MSA NATIONAL VW ENGEN POLO CUP CHAMPIONSHIP CIRCULAR 02 OF 2018

The following amendments to the National Polo Cup regulations are made with immediate effect:

Gearshift cable and selector swing arm modifications

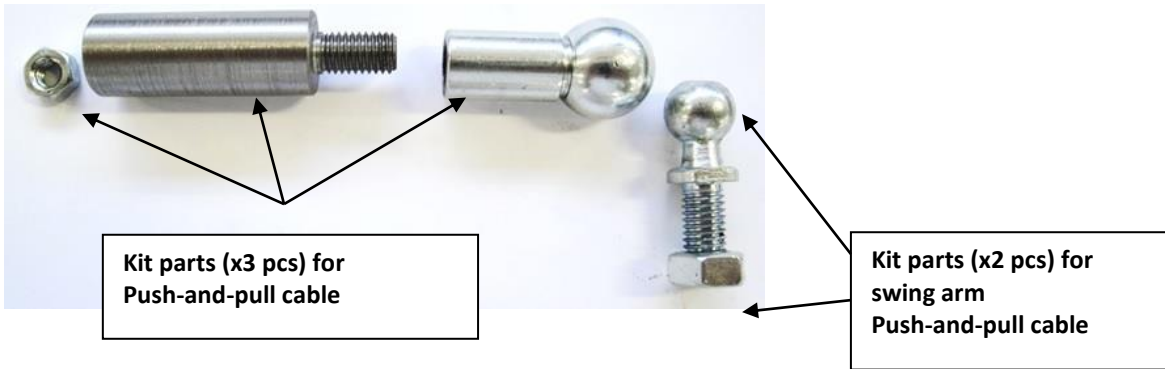
Modifications to the gearshift cable to please be done by the start of race meeting, Killarney, 20 April 2018. See instructions below.

The push-and-pull cable must be modified.
Other cable remains standard.

INSTRUCTIONS

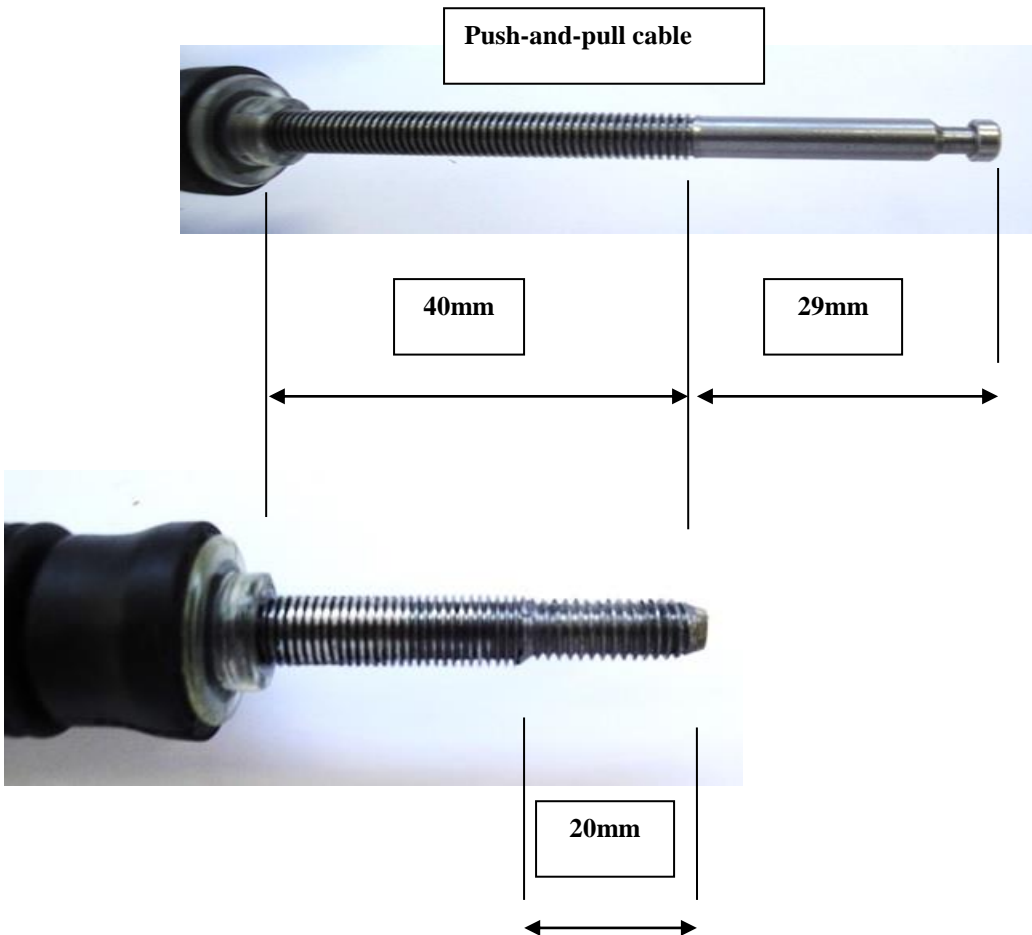
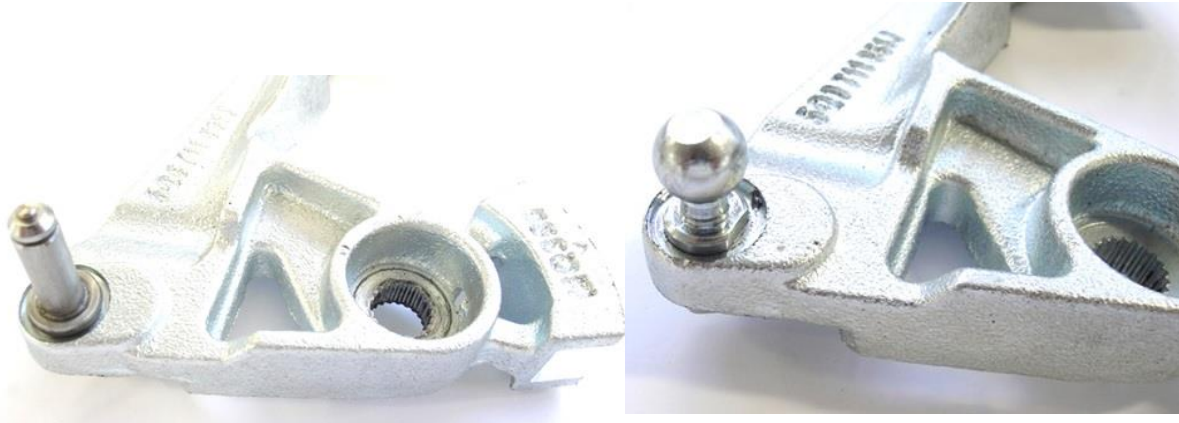
- 1.) Cut "nose" off from front of cable shaft.
- 2.) Tap shaft M6 (L=20mm)
- 3.) Install kit parts (x3 pcs)
- 4.) Remove pin from swing arm lever
- 5.) Install kit parts (x2 pcs)

Remove pin from swing arm lever.
Fit kit parts (x2 pcs)
